DOE/NASA/20320-63
NASA TM-86983

Government Review of the Mod-2 Wind Turbine (As-Built)

A Government committee was formed to conduct an as-built review of the three Mod-2 wind turbine units at Goldendale, Washington. The purpose of the review was (1) to identify any critical components and subassemblies which may be deficient in either strength or predicted service life, the failure of which would cause safety hazards or significant downtime and expensive repairs; and (2) to recommend any corrective action necessary to enable continued safe attended and unattended machine operation.

Figure 5. - Teeter bearing housing.

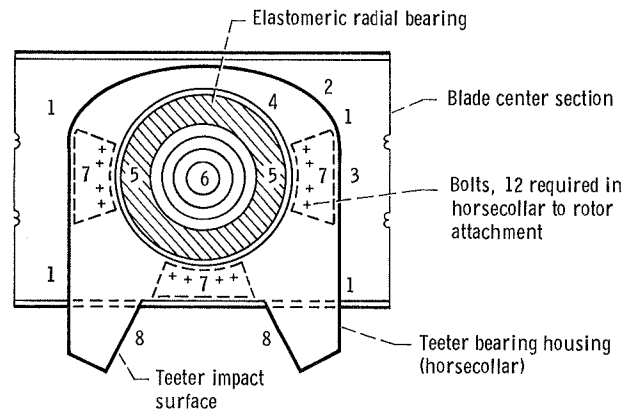
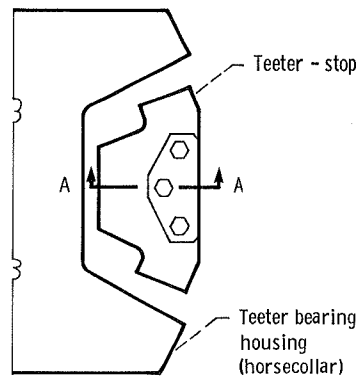
- (1) Iron oxide stains, indicating fretting at the horsecollar-to-rotor spar interface, were observed at location 1, figure 5, on all five Mod-2's.
- (2) Evidence of plastic shim failure was observed at location 7, figure 5, on WT4 and WT5.

- (3) Poor fit up (gap) at horsecollar-to-rotor spar interface was observed at location 3, figure 5, on WT5.
- (4) Weld flaws were observed at location 4, figure 5, on WT4; and a possible weld crack at the same location on WT2.

- (5) Surface cracks were observed on the elastomeric radial bearing at location 5, figure 5, on WT4.
- (6) A gap was observed at location 6, (see fig. 5) on WT4 between the elastomeric thrust bearing and rotor spar for the lower thrust bearing with the rotor horizontal, indicating a significant reduction in preload.

- (7) The bolts, location 7, figure 5, used to attach the horsecollar to the rotor, were torque checked. The torque measurements were lower than the original torque values at assembly.

- (8) Evidence of high teeter-stop loads at location 8, figure 5, were observed on WT5. This was presumably a result of nonoperating rotor-teeter motion in winds above cut-out velocity.

- (1) Design, fabricate, and install a teeter motion damper
- (2) Replace plastic shim between horsecollar and rotor with steel shim
- (3) Determine cause of loss of preload in thrust bearing and take corrective action

(View A-A)
Figure 6. - Teeter-stop details.

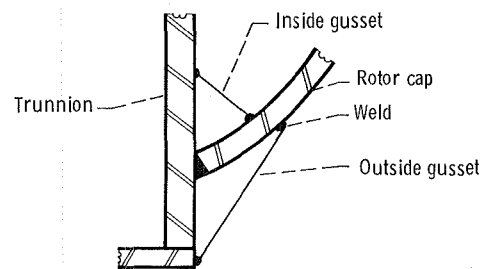
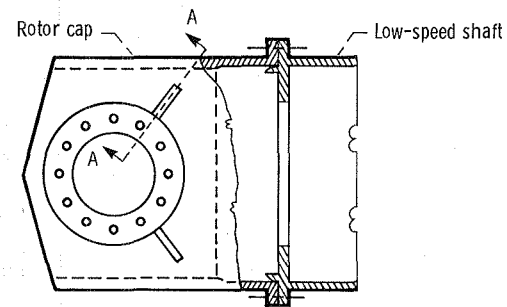
- (9) Analysis showed that the preload on the teeter-stop fitting bolts, figure 6, was insufficient to prevent slippage of the fitting.

(View A-A)
Figure 7. - Rotor cap details.

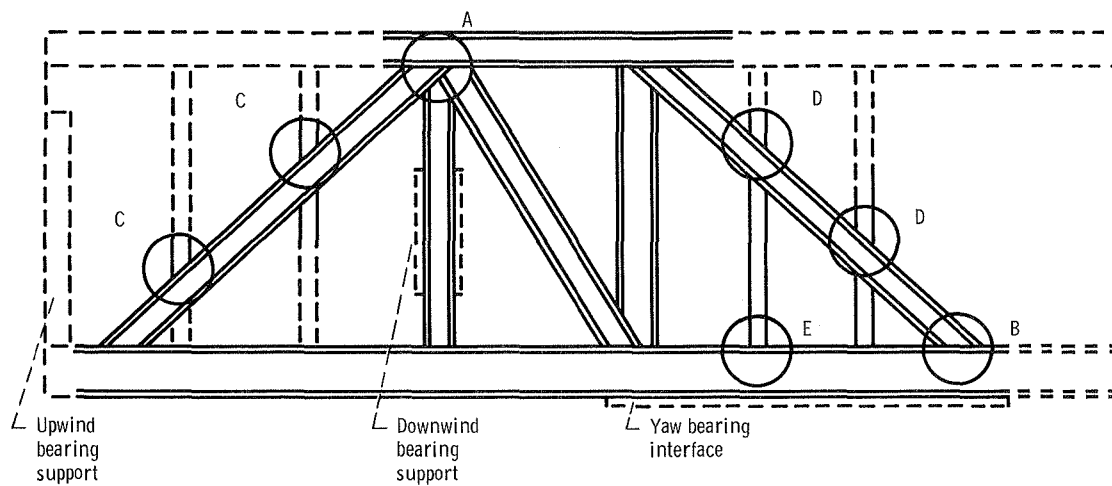
The Government inspection found 8, 0.5-in-diameter holes drilled through the cylindrical wall of the rotor cap at station 1 and station 19 as shown in the BEC drawing 032-418000. The purpose of these holes is for inserting bolts used to secure hydraulic line brackets. Structural analysis of the rotor cap to take into account the effects of these holes on the structural integrity of the rotor cap was not done.

- (1) Increase bolt size and preload at low-speed shaft-to-rotor cap interface
- (2) Install additional gusset plates, as required, at trunnion and rotor cap intersection weld
- (3) Repair or redesign pilot interface
- (4) Grind fillet weld wrench marks and increase washer thickness to provide adequate clearance

Figure 8. - Nacelle and major bearing support details.

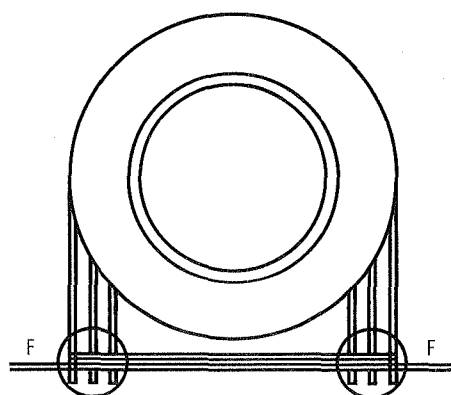
Findings: Inspection of the downwind bearing supports, shown in figure 8, indicated the following:

A visual inspection of critical weld areas in the nacelle did not identify any failures. The fatigue analysis estimated "time to repair" values varying from 6 mo to 10 yr as shown in figure 8. The analysis was based on the assumptions listed in appendix D.

Figure 10. - Metal slivers removed from yaw ring gear.

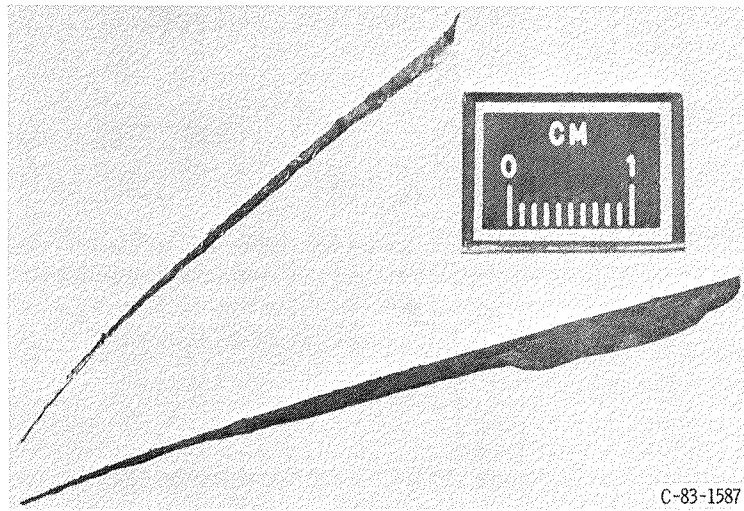
The pinion gear specification calls for heat treatment to BHN 350/425. The ring gear specification calls for heat treatment to BHN 250/300. With the pinion gear having the harder surface, alignment and tooth surface contact become very important. Without proper alignment and tooth contact, excessive wear and possible tooth breakage can occur. Slivers of metal, as shown in figure 10, were removed from one ring gear.

Figure 11. - Yaw drive motor pressures during yaw corrections. (Rotor speed = 17.5 rpm.)

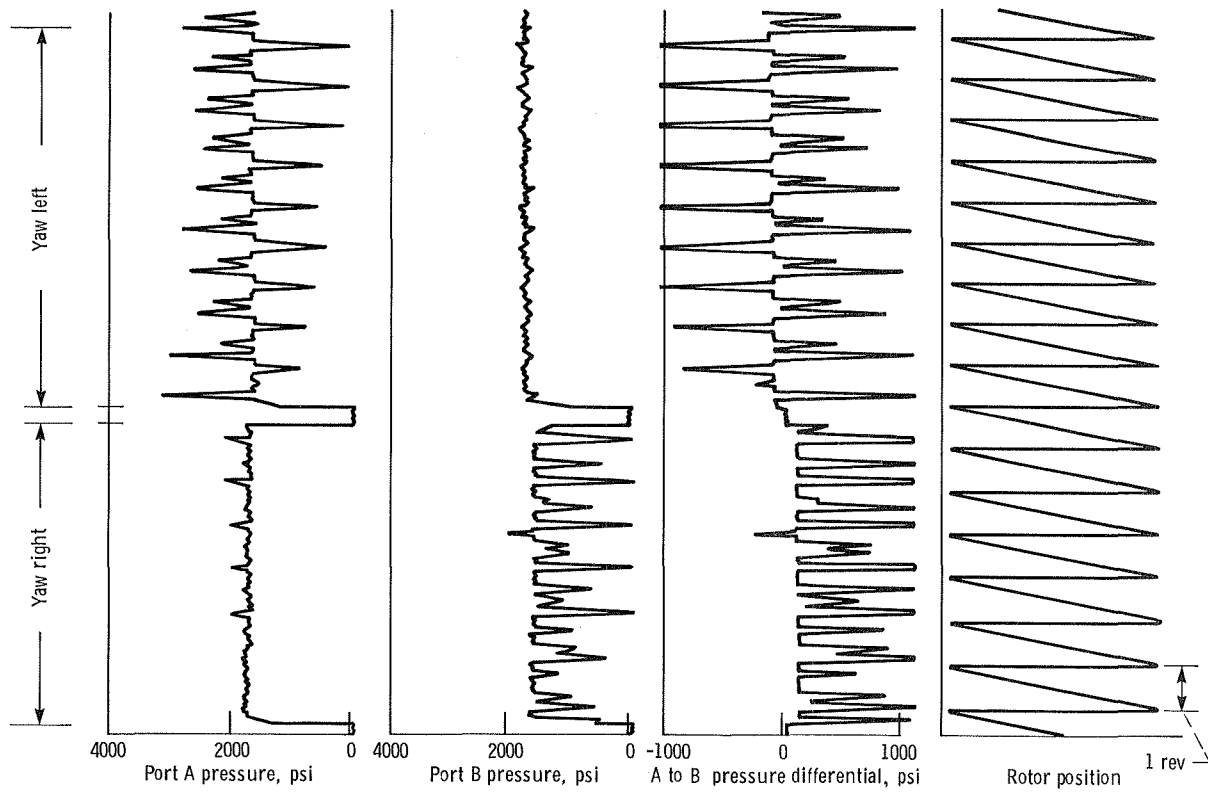
During Mod-2 operation, just prior to the low-speed shaft failure, measurements of hydraulic pressure at the yaw drive motor ports were made. These measurements, shown in figure 11, showed pressure impulses of close to 2000 psi (system design pressure) when yawing took place while the rotor was at normal operating speed (17.5 rpm). If yawing took place when the rotor was coming up to operating speed, higher peak impulse pressures were observed. The impulsive nature of the pressure measurements is a result of the cyclic yawing moments produced by the rotor and backlash in the gear teeth. Because of the backlash, the nacelle can rotate through a small angle unrestrained except for friction in the yaw bearing. This motion continues until the ring gear impacts the pinion gear causing a pressure spike in the drive motor.

These pressure measurements provide evidence that the yaw drive system was being subjected to loading that was not considered in its design. Design torques for the yaw drive gearbox were 11 600 ft-lb steady and 37 500 ft-lb limit. There was no specification for cyclic loading. Estimated actual loading was based on yaw drive motor pressure measurements. Measured steady or mean torque was about 5000 ft-lb and measured cyclic peak torque was about 32 500 ft-lb. The frequency of the cyclic torque was about one per rev, instead of the anticipated two per rev, indicating blade-to-blade imbalance. The effect of this loading on yaw gearbox life has not been assessed.

Figure 12. - Solano (WT5) tower crack, view looking east. (Subsurface defects are directly below surface defects.)

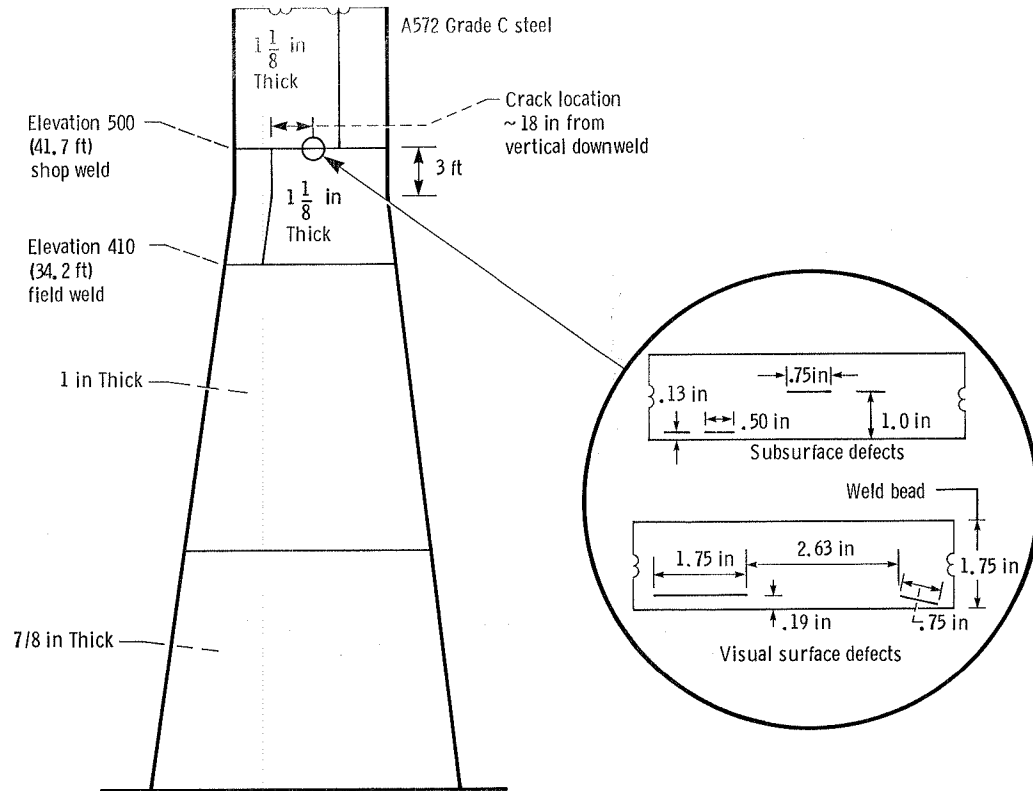
Findings: It is important to note that the Solano flaw, shown in figure 12, was first detected by an observation of rust stains on the exterior surface of the weld. Furthermore, this observation made by a BEC individual involved in another site assignment, proves that a 1.75-in crack can be detected by a visual inspection.

- (1) Audit all radiographs now in existence and/or reradiograph
- (2) Remove all reinforcement from the inside welds and penetrant inspect
- (3) Visually inspect tower every 600 hr

Figure 14. - Gin pole system.

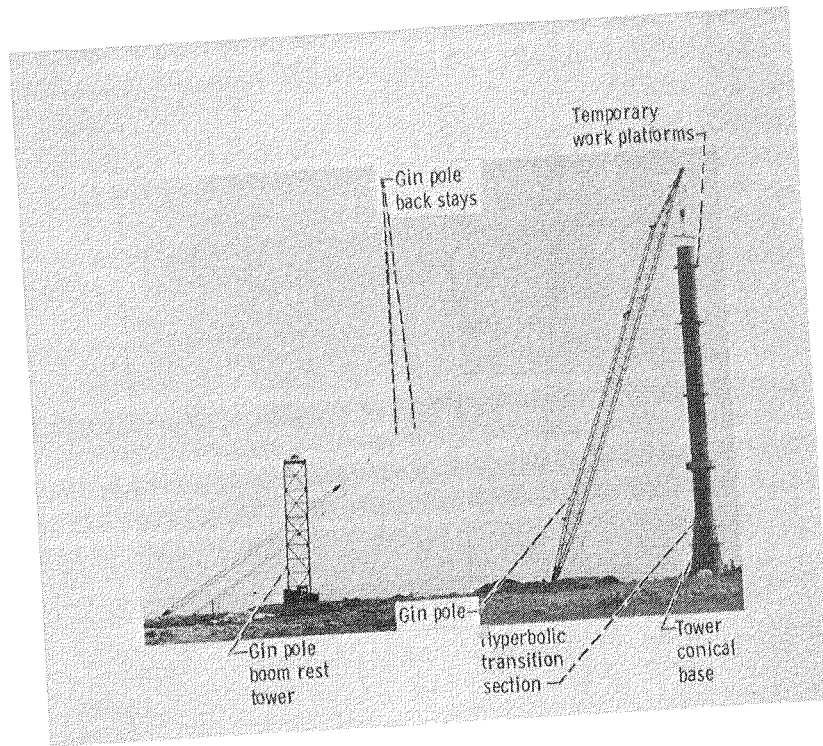
Findings: The gin pole system has performed satisfactorily to date except for a failure of a backstay anchor plate on WT1. Fortunately, the failure did not occur during a lift but while the cables were being straightened with the boom on the boom rest. The anchor plate failed because it was subjected to offset loading not considered in its design. All anchors were subsequently modified to handle offset loading.

Due to an increase in the weight of the new low-speed shaft design of 10 250 lb, additional weight must be added to the proof load test assembly to meet the requirements of ANSI B 30.7-1977, para 7-2.2.2.

- (1) Add additional weight to the existing gin pole proof load to compensate for the increase in weight from modifications including new low-speed shaft assembly
- (2) Incorporate formal gin pole Operations and Maintenance procedures which include assembly, disassembly, operation, proof test loads, maintenance, inspection, and corrosion prevention in the Operations and Maintenance manual
- (3) Provide environmental protection of the gin pole winch assembly

Figure 16. - Rotor spindle assembly.

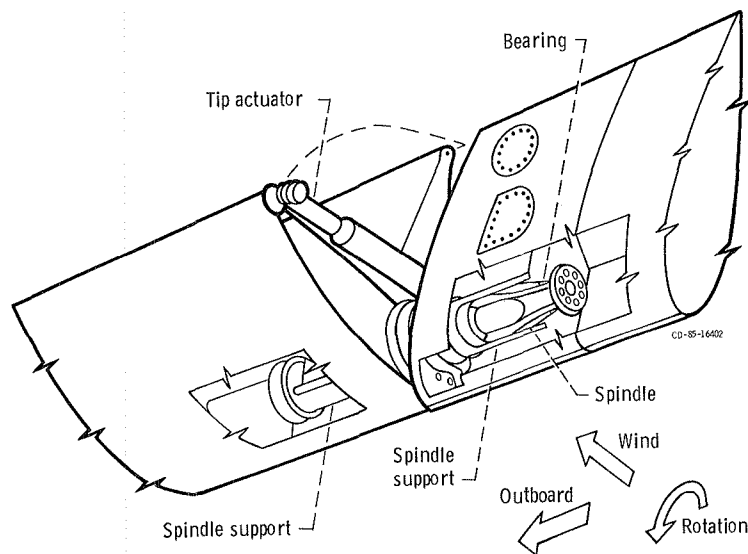
Findings: The bearing preload was maintained by six Belleville spring washers installed on the rotor spindle in two stacked sets of three washers for each blade. These washers were installed as specified on Boeing drawing 032-411311 and bench calibrated for exact stack height versus 168 000-lb design preload. Each match stacked set was cycled through a minimum of four, 0 to 168 000-lb loads, versus measured heights. Data reviewed showed excellent consistency or uniformity of spring rates (nominally 400 000 lb/in) with a maximum deviation of 0.001 in between the four heights measured during the calibration bench tests. The stacked height measurement is then permanently stamped to the rotor-spindle flange for the respective Belleville washer set installed. Each set is lubricated with grease during final installation to prevent corrosion.

An inspection of the flange face of the blade midsection to which the rotor spindle assembly mates revealed that several of the tapped holes had been modified with threaded inserts. These were used because the original threads were stripped during handling operations prior to shipment to the site. This handling was accomplished by using too few bolts for the load, and thus the threads were stripped. If all bolts had been used in maneuvering the blade, no problem would have occurred. In any event, the use of inserts does not degrade the structural integrity or load capacity of an individual hole. However, as a precautionary measure, a recommendation for inspection of these inserts has been made.

- (2) Replace the plastic shim material between highly preloaded flange faces with steel material
- (3) Inspect the flange to determine if inserts provide a satisfactory long-term repair

Figure 18. - Gearbox details.

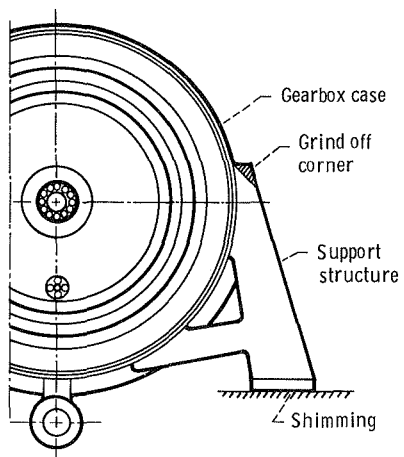
Findings: The gearbox, shown in figure 18, has proven trouble free with only a few instances of lubricating oil leakage. The overspeed incident has shown it to be capable of sustaining high overloads without damage. During the incident, input torque reached 3.96×10^6 ft-lb or 360 percent of rated torque, compared to the design limit torque of 1.65×10^6 ft-lb.

Dye penetrant inspection and strain gauging of the suspect weld on the Mod-2 gearbox revealed no problems. However, analysis showed that stress could be reduced by minor rework of the weld detail.

- (1) Rework the detail at the intersection of the gearbox case and support structure to reduce stress in the weld

Figure 20. - Typical induction disk relay.

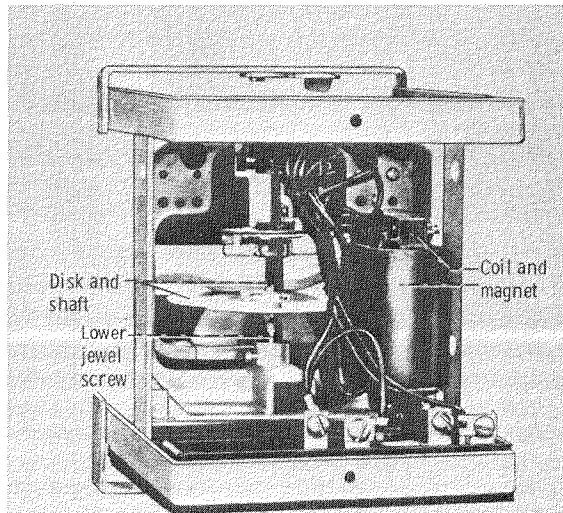
Five of the induction disk relays were opened to permit examination of the shaft, bearing, and bearing surface. Figure 20 shows a back view of a typical induction disc relay. The disk is mounted on a vertical shaft which pivots on upper and lower pins. The top bearing consists of a pin in the relay body which fits into a sleeve insert in the shaft. The bottom bearing consists of a pin which protrudes from the bottom of the disk shaft that rides on a jeweled surface. The disk is actuated by an induced magnetic field. The disk shaft is restrained by a spiral spring and its motion is retarded by a permanent magnet acting on the disk to give the correct time delay. The differential relay (87) and the loss of excitation relay (40) were not opened for examination because of the difficulty to "tear down".

Figure 25. - Overspeed sensing circuitry.

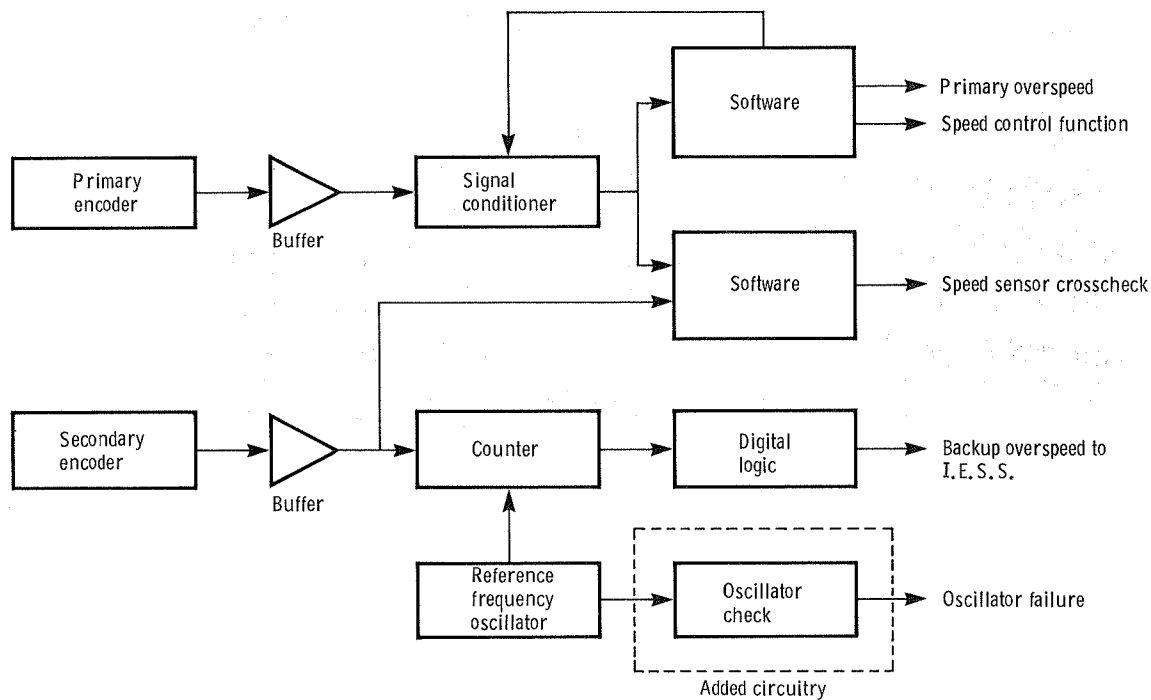
The sensing, shown in figure 25, consists of two encoders of similar but not identical installation and manufacture, thus eliminating the likelihood of simultaneous generic failures. One sensor used for the speed control function, also generates the primary overspeed signal which actuates the start and stop valves. This circuitry, located in the microprocessor rack was used continuously during normal running. Thus, most failures were detectable and failsafe or had a built-in backup mode, such as feathering the blade with servo valves if the start and stop valves did not function.

Figure 26. - Wind turbine control communications link.

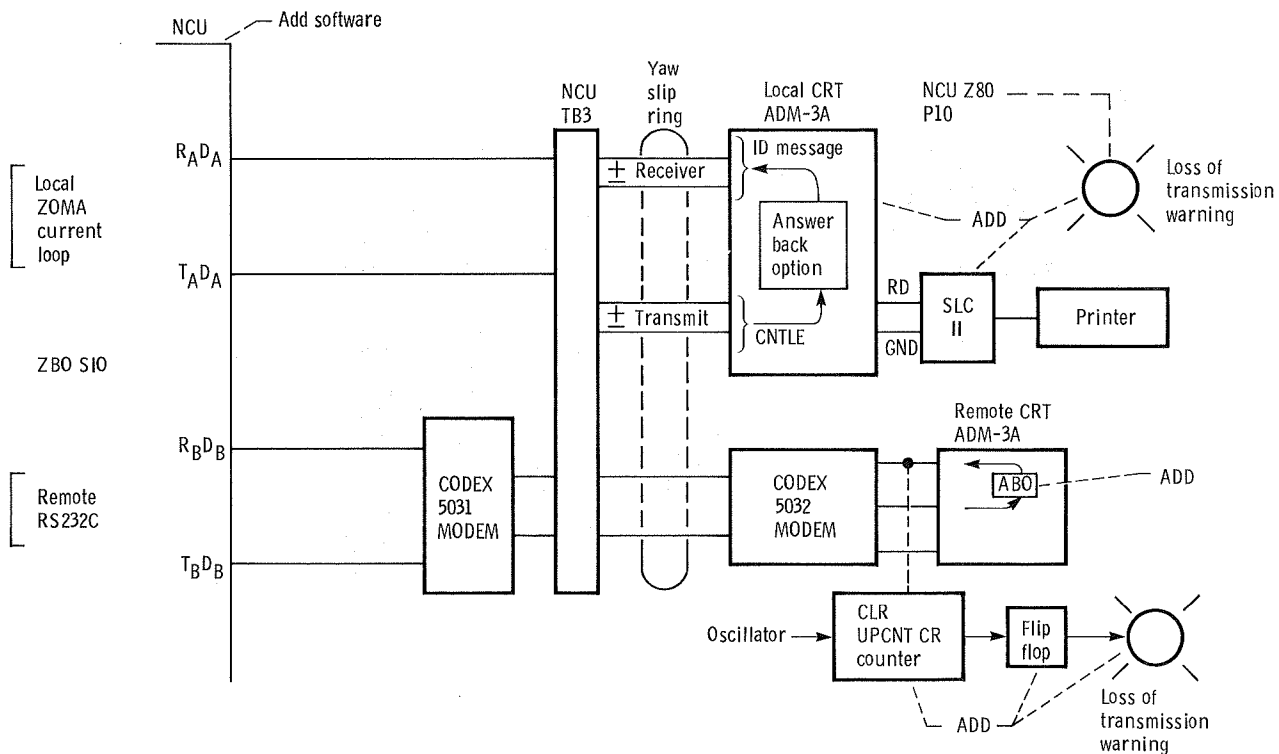
An answerback feature could be added to the CRT display terminal (see figure 26). Software added to the NCU would send a signal to the local and remote CRT's, which would echo back an ID message response to the NCU. If the answerback loop is broken, then an alarm is initiated at the local and remote terminals. A message counter would be added to the remote receiver line to power the remote alarm. This scheme will check all wires and circuits of the transmit and receive serial links for proper function.

- (1) Add answerback feature hardware and software to the display terminals

Figure 28. - Wind turbine yaw slipring anti-rotation restraint.

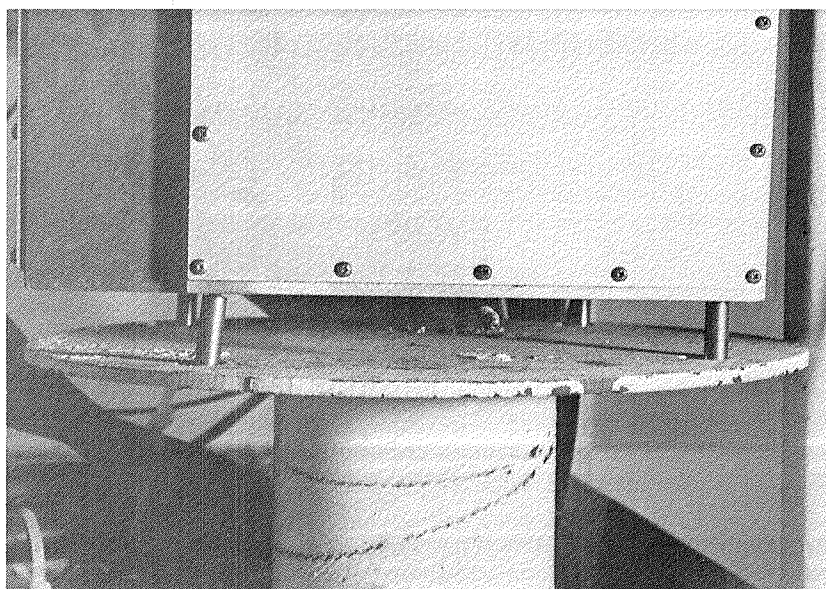
The antirotation bracket on WT2 (see figure 28) showed some deformation where the existing bolts, that act as antirotation restraints were attached. Inspections of this installation and others give the impression that misalignment might exist between the rotating and stationary fixtures of the yaw slipring assembly. This could cause bending loads to be placed on the assembly by the antirotation brackets and bolt restraints.

- (1) Inspect the sliprings for contamination and measure resistance on the power rings
- (2) Inspect and replace the molded HV cable termination boots as required, and install a drip shield to prevent further oil contamination
- (3) Replace the existing antirotation restraint with an improved design which can not load the yaw slipring
